Staff Report

Report To:	Planning and Development Committee		
Date of Meeting:	December 7, 2020	Report Number:	PSD-055-20
Submitted By:	Faye Langmaid, Acting Director of Planning and Development		
Reviewed By:	Andrew C. Allison, CAO	Resolution#:	PD-211-20, PD-212,20 C,529-20
File Number:	COPA 2020-0002; PLN 41.10	By-law Number:	
Report Subject:	Southeast Courtice Secondary Plan – Recommendation Report for Official Plan Amendment 124

Figure 46: Type C Arterial Cross-section and Plan

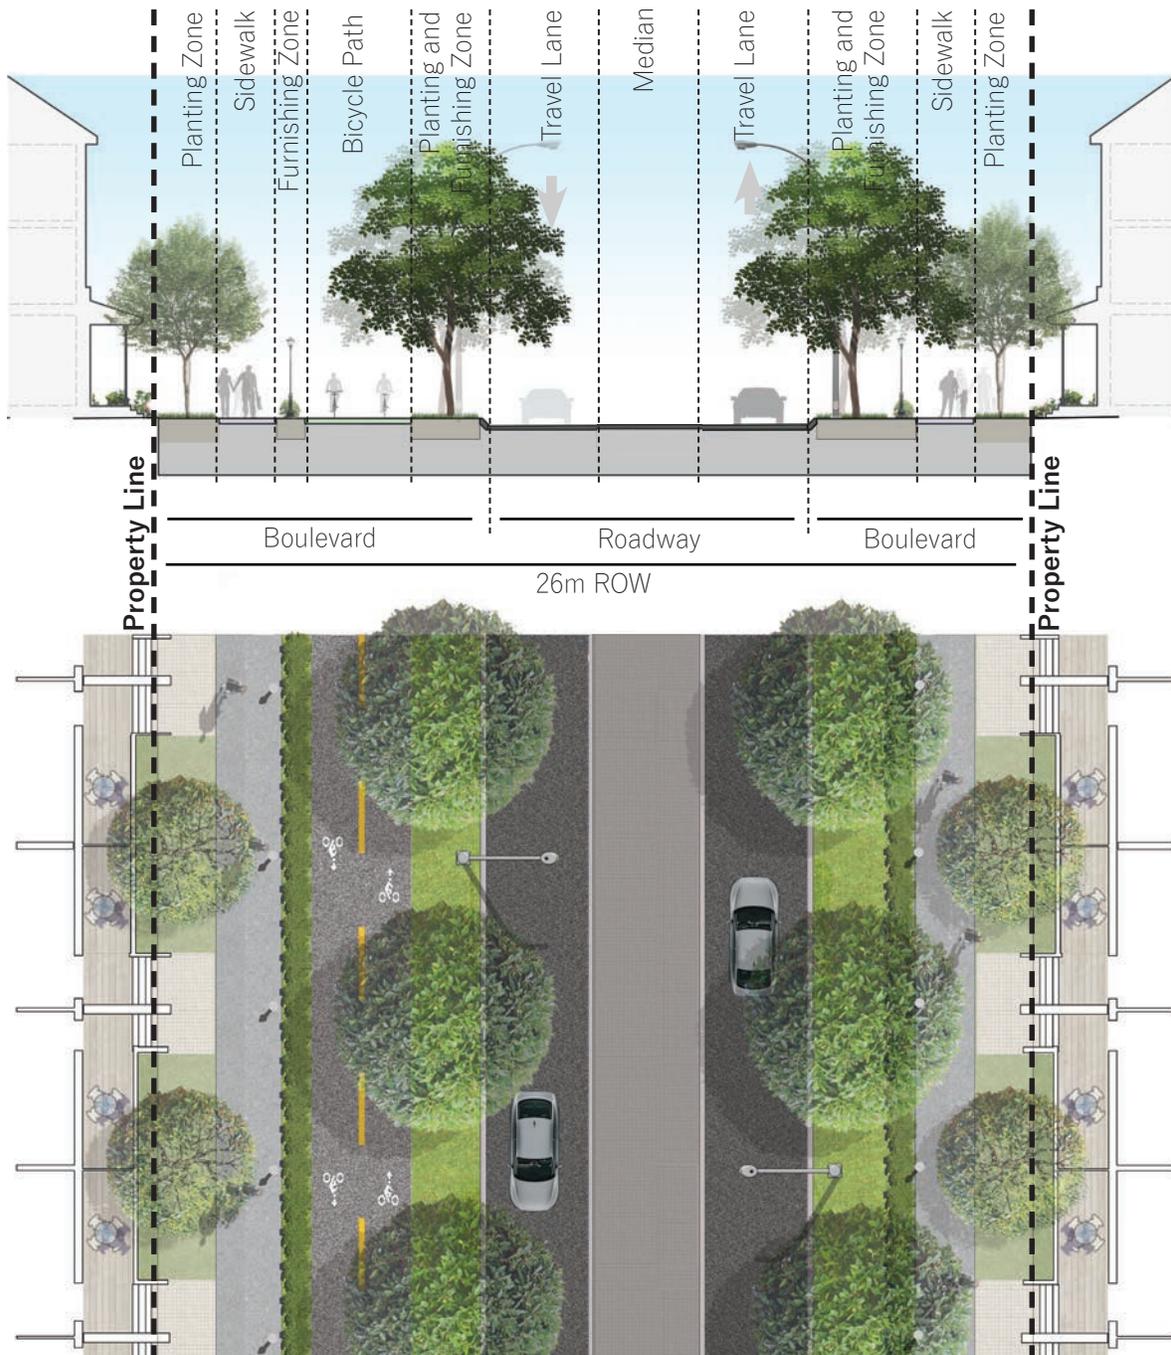
Submission Number Name (contact) Date	Details of Submission	Response
	<p>provided below). The Arterial Corridor Guidelines do contain ROW Cross Sections, however, only offer one 45m Major Transit Corridor ROW Cross Section which the UDG Figure 18 does not match.</p> <ul style="list-style-type: none"> • <u>Regional Transportation Master Plan found here:</u> https://durhamtmp.files.wordpress.com/2018/07/durhamtmp_finalreport_2018-0709-web-accessible.pdf • Arterial Corridor Guidelines: (Skip to Sec2:70 for 45m ROW Cross Section) https://www.durham.ca/en/living-here/resources/Documents/EnvironmentalStability/Arterial-Corridor-Guidelines.pdf • Cross-section is huge. Planting islands of 3.0 meters are too narrow to ensure positive tree growth. 	See revised UDSGs.
	<p>Figure 20: Arterial C</p> <ul style="list-style-type: none"> • Single lanes on an Arterial road is impractical and rules out ever having buses, on-street parking, or deliveries on these roads. There may also be issues with emergence vehicles... • The Regional Arterial Corridor Guidelines have a 26m Two Lane Residential Cross Section that does not match Figure 20 of the UDG. • More reasonable cross-section, however 3.5 meter travel lanes do not provide for emergency vehicle access. Additionally, the boulevard is very clustered. 	See the revised UDSGs for Figure 46.

Figure 49: Rear Lane Cross-section and Plan

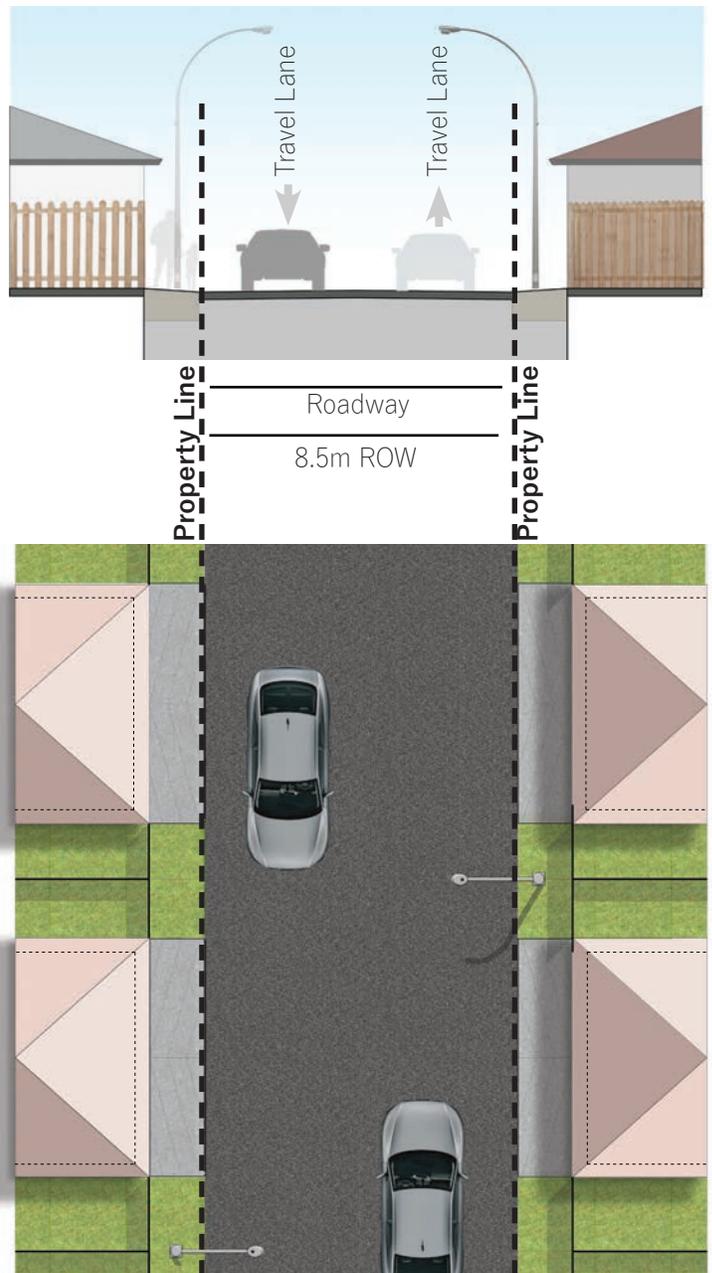
<p>Figure 21: Collector Road</p> <ul style="list-style-type: none"> • This cross-section has the same issues - particularly since school boards often require schools to be located on Collector Roads and this cross-section would make it difficult to have school busses stopping. 	See the revised UDSGs Figure 47.
	<p>Figure 23: Laneways</p> <ul style="list-style-type: none"> • The plan does not show that laneways connect to other laneways and form a system as described in the text. 	See Secondary Plan policy. Lanes must connect to a public

Submission Number Name (contact) Date	Details of Submission	Response
		street. See the revised UDSGs 6.3.6 Figure 49.
	<p>Figure 24: On-Street Parking - Typical Layout</p> <ul style="list-style-type: none"> • There are no driveways or roads identified accessing the development block either from the local road or the Regional corridor. • Not the best example of development block, it would be possible to access only from the east side. 	Graphic removed.
	<p>Figure 26: Green Street Strategies</p> <ul style="list-style-type: none"> • The rendering is very misleading since it shows almost no driveways cutting across the bioswales and the lot density shown is much lower than what is being proposed. • Green Streets. Photo doesn't match any of the proposed road cross-sections nor housing forms (widths-as noted previously) 	Graphics have all been revised. See the revised UDSGs.
	<p>Figure 27: Active Transportation Network</p> <ul style="list-style-type: none"> • An error in the legend on road identification. Should eliminate local roads. • POPs are not clear, no explanation 	<p>See the revised UDSGs Figure 51.</p> <p>Graphic is for demonstration.</p>
